Version 6

Safety Recall: 2020 MDX Seat Weight Sensor (DTC U3000-49)

Supersedes Version 5 to revise information at:

PARTS INFORMATION update

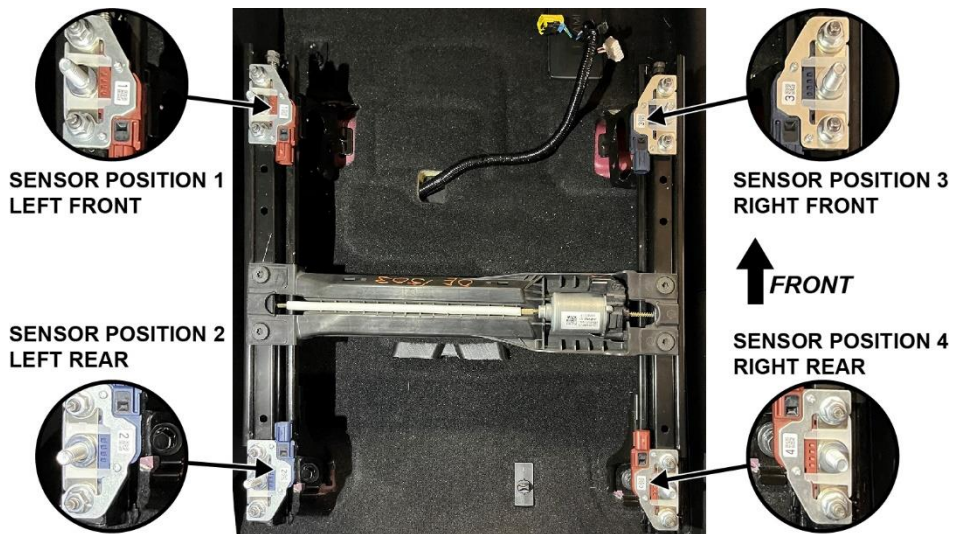
11. Install the new sensors and nuts in the orientation as shown.

NOTE: The new sensors have a number for installation in the correct location.

SWS FIXTURE GUIDE

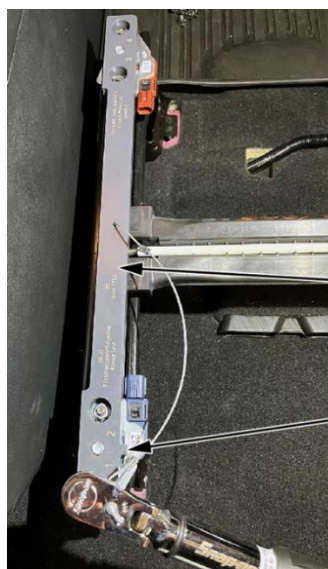
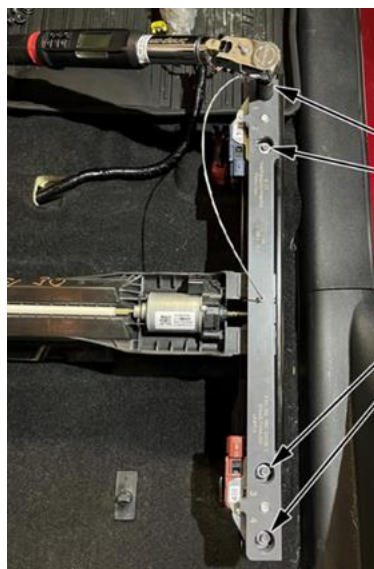
12. Place the **SWS Fixture Guide C** onto the new seat weight sensors with the tabs located to the inside of the seat track. **With the guide properly seated on the new sensors, torque nuts to 35 N·m (26 lb-ft) in the order shown on the SWS Fixture Guide.**

NOTE: Use the socket provided with the guide.

TABS
Tabs located to the inside.

8mm NUTS
35 N·m (26 lb-ft)

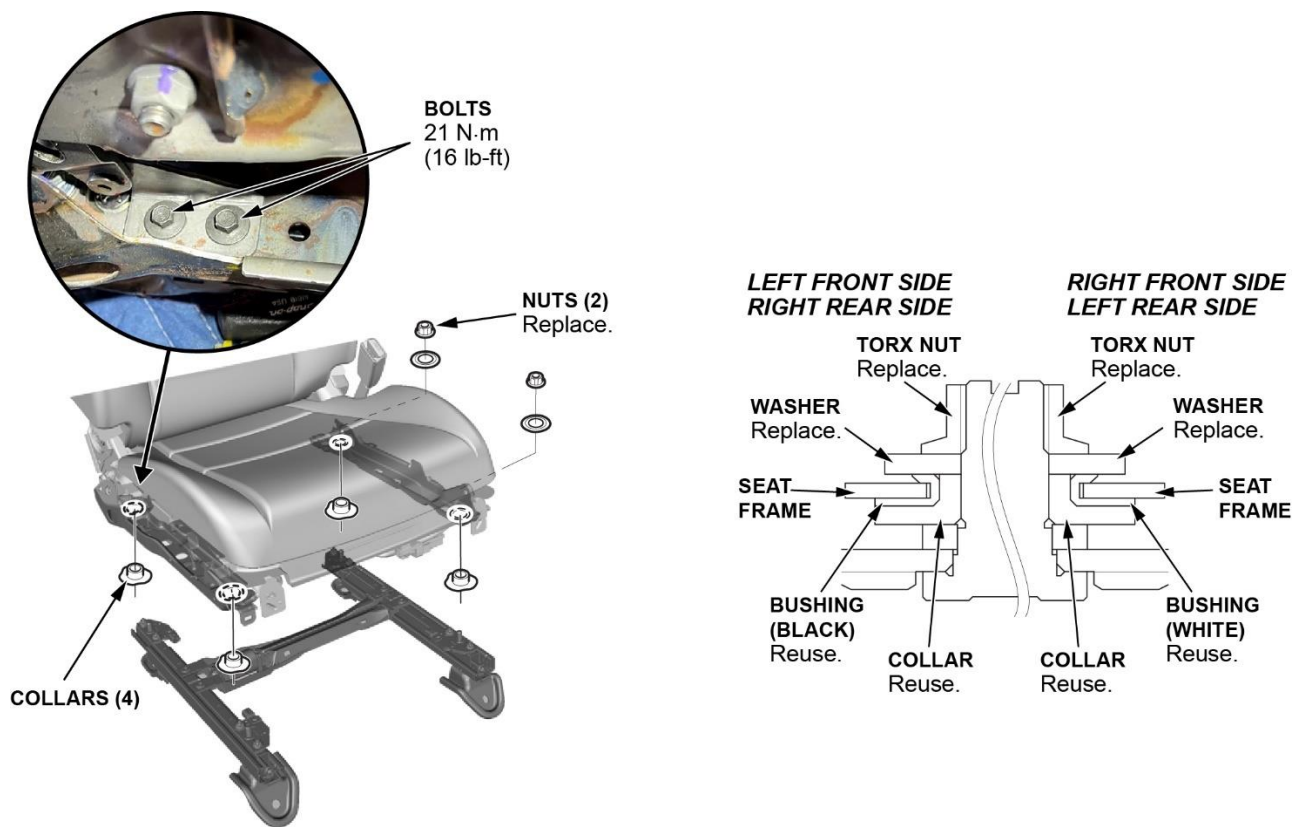
13. Remove the rail from the vehicle. Install the front passenger's seat rail back onto the seat frame, loosely install the new nuts and bolts, and reinstall all parts.

NOTE: The bushings and collars can be identified by their color. Make sure to install the bushings and collars as shown.

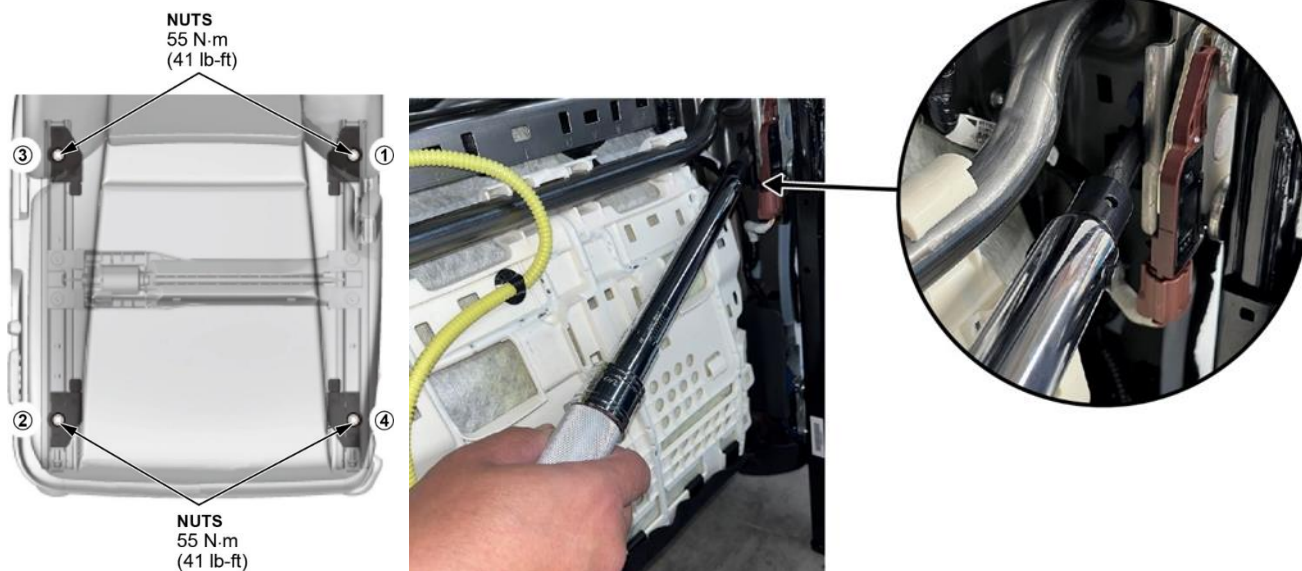
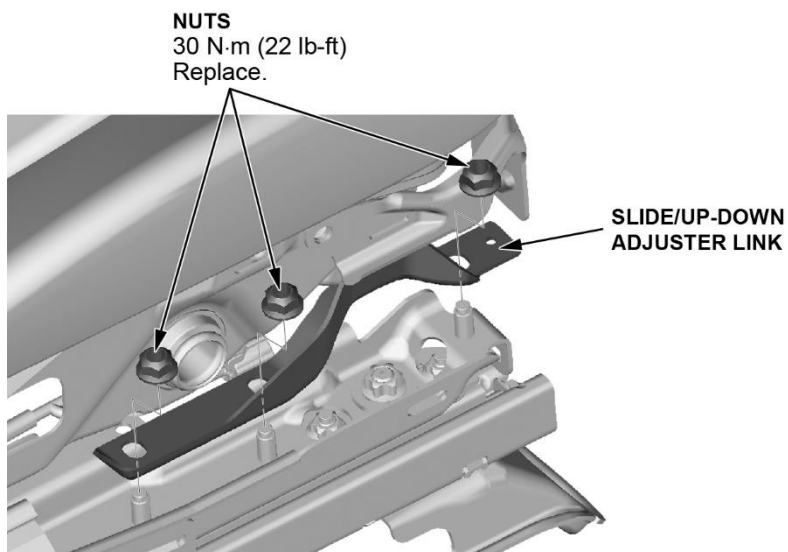
14. Torque the nuts to **55 N·m (41 lb-ft)**.

NOTE: Use the Snap-On Torque Wrench (P/N QD21N100A) and box-end head to tighten the seat rail nuts.

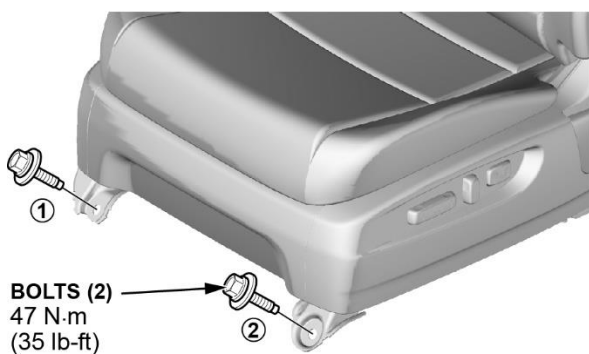
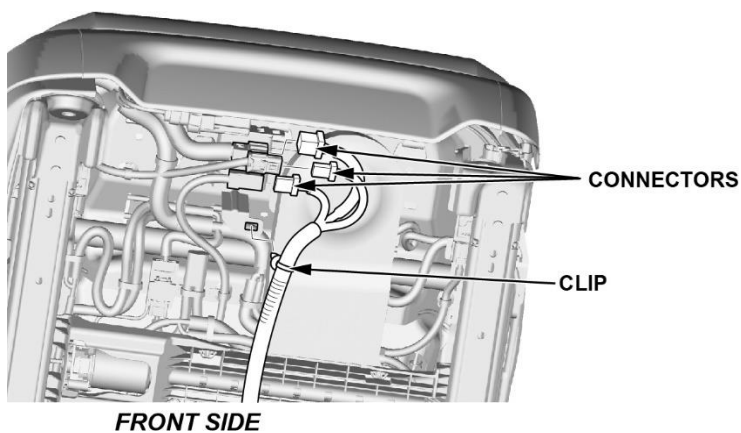
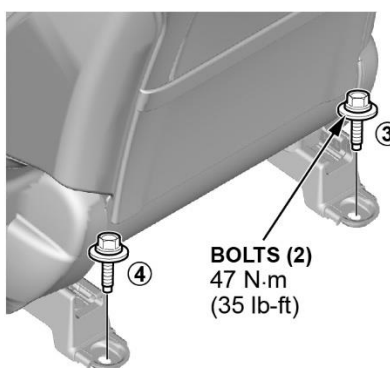
17. Install the seat into the vehicle, connect the connectors, and clip.

NOTE: When installing the seat, tighten the bolts by hand first, then tighten them to the specified torque **47 N·m (35 lb-ft)** in the sequence shown.
